PUBLIC UTILITIES COMMISSION

GA2014-04

SUBJECT: General Order 112-E Gas Audit of PG&E's Sierra Division

SUMMARY OF INSPECTION FINDINGS

Photo 2- Atmospheric Corrosion observed on Valve 5 located at Regulator Station MRB-99

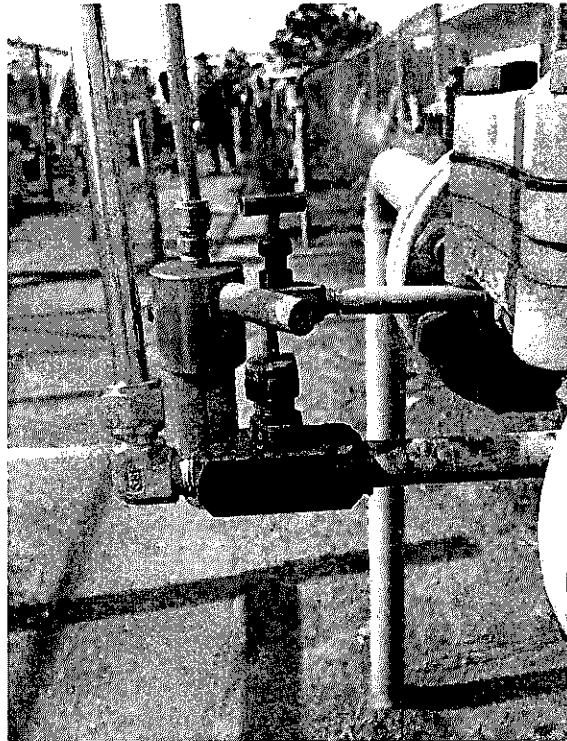
2.3 On 5/1/14, SED and PG&E visited Regulator Station, MRB-99, located on 6th Street and Walnut Street in Marysville to exercise valves. SED observed Atmospheric Corrosion (AC) on bleed sense part of the regulator station.

Photo 3- Leaking valve located at the bottom of the filter cylinder that was replaced during field visit on May 1, 2014 at Regulator Station MRB-73A

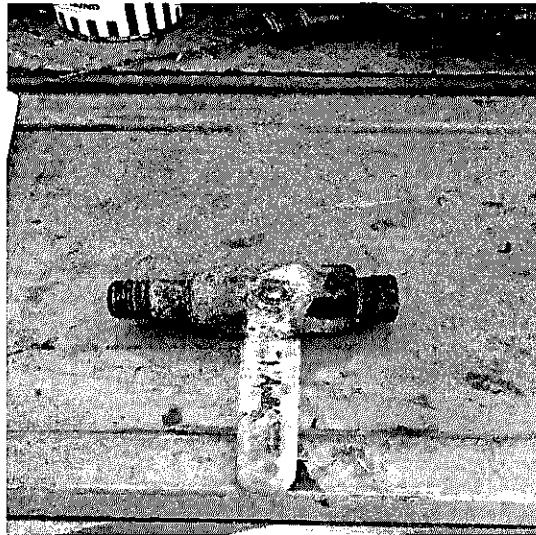
1. On 5/1/14, SED and PG&E visited Regulator Stations, MRB-73A and MRB-73 located on Township & Almandra in Yuba City. SED noted the following deficiencies at these regulator stations:
 - Station diagram for both stations shows Valve 13 which no longer exists since PG&E removed it. Division needs to update the station diagram. Please provide SED with a copy of the revised diagram.
 - During the field check, PG&E crews found a fuzz leak on the stand-by (left) side of the monitor (upstream vault) of the Regulator Station MRB-73A and repaired it by removing the old ball valve, shown in Photo 3, and replaced it with ½" ball valve. After the repair, crew soap tested it and did not find any leaks.

Photo 4- Span L-124B at MP 22.59

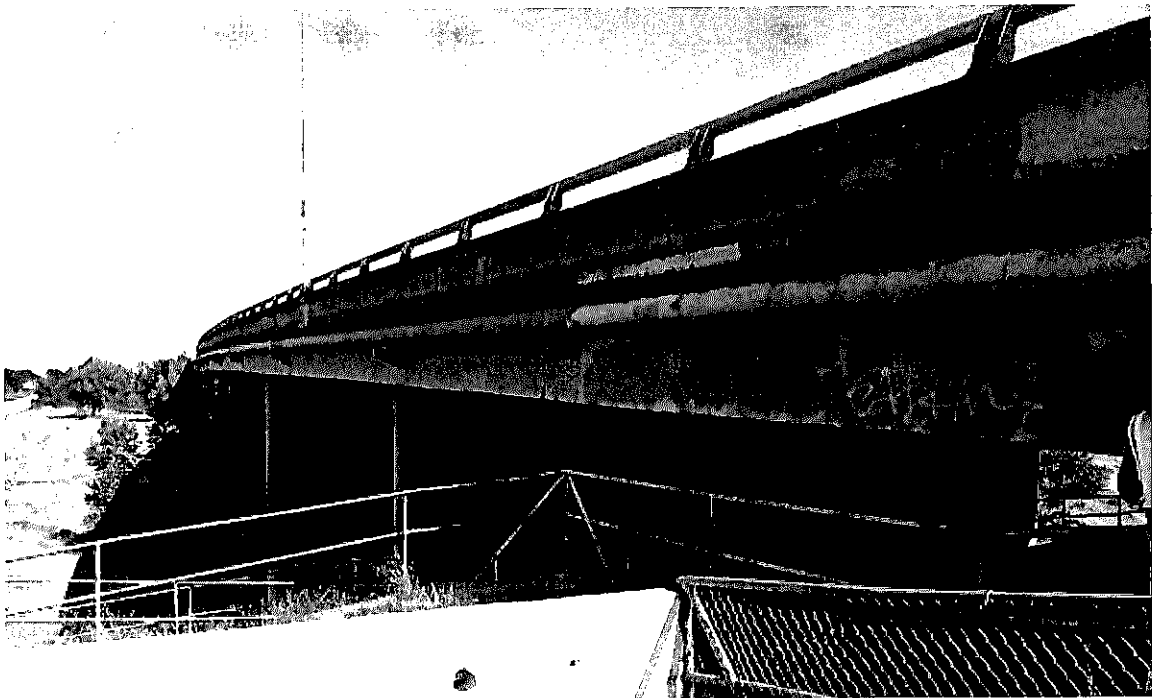
- a. Maintenance record of transmission valve V-7 Tap SAP WM NO. 41431641 was incomplete. Division staff didn't check the box on transmission valve type (EMERGENCY or OTHER).
 - b. Maintenance record of transmission valve V - 38.05 SAP WM NO. C-A010 42577652 was incomplete. Division staff didn't fill out the service history completely on 5/28/2013, missing information on columns (OPERATE and VALVE POSITION).
6. On May 2, 2014, during a field visit to a pipe span on Line 124B, SED observed a comprised pipe hanger on the north side of the span, shown in Photo 4. The concrete around the anchor bolts supporting the pipe hanger appeared to be crumbling. Additionally, pipeline markers were not visible at the time of the field visit.

Please provide SED with an update on the Division's follow up actions.
